## V. DePierre[6]

## W. R. D. Wilson[7]

## Author's Closure

**Fig. 23**

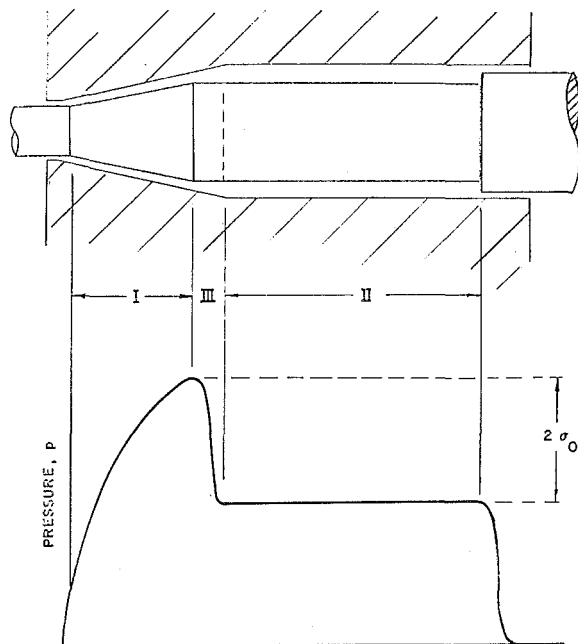
in both zones I and II, but the deformation states in the two zones are quite different. In Zone I, the workpiece is being elongated in the axial direction and compressed in the radial direction and the relationship is correct. However, in Zone II, the workpiece is tending to be upset under the action of the punch load. Thus, it is tending to expand radially and contract axially and the yield criterion should read

$$\sigma_x + p = -\sigma_0. \tag{110}$$

The condition given in equation (2) requires that the axial compressive stress exerted by the punch is less than the radial pressure of the lubricant. If this were true, lubricant would be forced into the space between the billet and punch and the extrusion process would become hydrostatic.

Now the equation of axial equilibrium requires that the axial stress $\sigma_x$ must be continuous between Zones I and II. Thus, the use of equation (2) in Zone I and equation (110) in Zone II requires a step change in the lubricant pressure $p$ by an amount $2\sigma_0$ on passing from Zone I to Zone II. This can only be accommodated by assuming that a short Zone III in which the material is rigid exists between Zones I and II as shown in Figure 23. This will allow a sudden decrease in film thickness between Zones II and I with the consequent increase in lubricant pressure. This type of hydrodynamic inlet region has been discussed by Walowit and Wilson[8] with reference to drawing and rolling.

Since the amount of lubricant passing out through the die throat is now no longer equal to the volume swept out by the stem some compensating leakage past the stem must be allowed. If this does not occur, then the pressure in the lubricant film will rise to a greater value than the stem pressure and the extrusion will become hydrostatic.

The approach outlined in the foregoing will allow the calculation of the exit film thickness $h_e$ in terms of the other process parameters including the applied coating thickness. If the coating thickness is large compared with the exit thickness (as is usually the case) then the exit thickness is almost independent of the applied coating thickness and the billet/container friction is small.

For the present paper, in the absence of rigid material between Zone I and II, $\sigma_x + p = \sigma_0$ is valid for both Zone I and II, in view of the continuity of $p$ and $\sigma_x$ at the interface of two zones. However, if rigid material, suggested by Dr. Wilson in Zone III, is introduced to exist between Zones I and II, the expression of $\sigma_x + p = -\sigma_0$ is than valid for Zone II. This is due to rigid body on the left side of Zone II.
